SSDA 8865 MOD 1- RESPONSE TO REQUEST FOR FURTHER INFORMATION

This letter has been prepared by Urbis Pty Ltd on behalf of Sydney Catholic Schools (SCS) in respect of the Section 4.55(2) application to modify the State Significant Development Application (SSD-8865) for concept approval and the staged construction of the St Anthony of Padua Catholic College at 125-165 Tenth Avenue and 140-170 Eleventh Avenue, Austral NSW 2179 (the project).

Figure 1 Construction Phasing – SSDA 8865

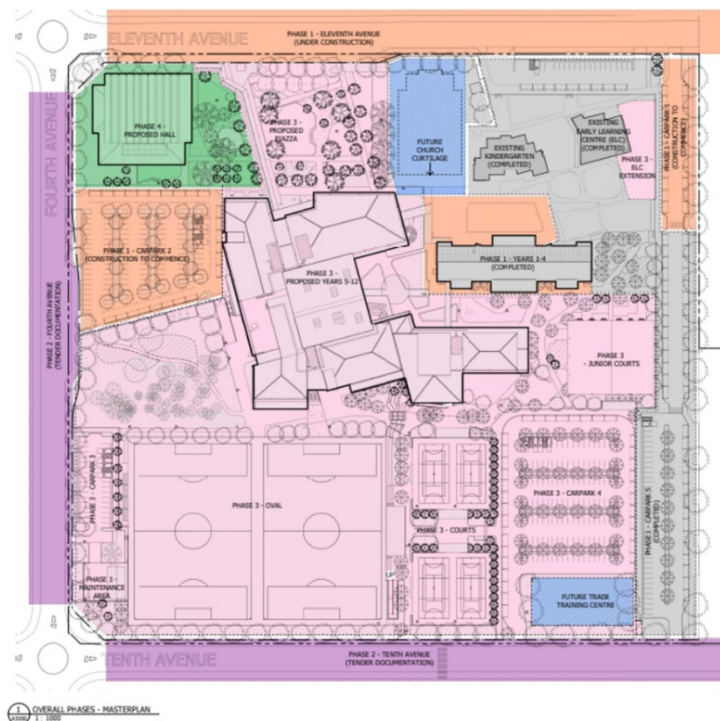
A review of the construction programme and available funding has resulted in changes to the construction phasing. The construction phasing identified in SSDA 8865 MOD 1 is proposed to be amended as follows:

- Carpark 3 in the south west of the site has been moved from Construction Phase 1 to Construction Phase 3
- The ovals have been moved from Construction Phase 1 to Construction Phase 3

Improvements have been made to the presentation of the phasing diagrams to clearly differentiate between completed project elements as the construction phases progress. These consist of:

- Identification in the plans of completed buildings, carpark and road works.
- Completed outdoor play areas showing in a light grey, not green.

Figure 1 below shows all the proposed construction phases. The complete set of updated staging plans is included in the Architectural plans at **Attachment A**.
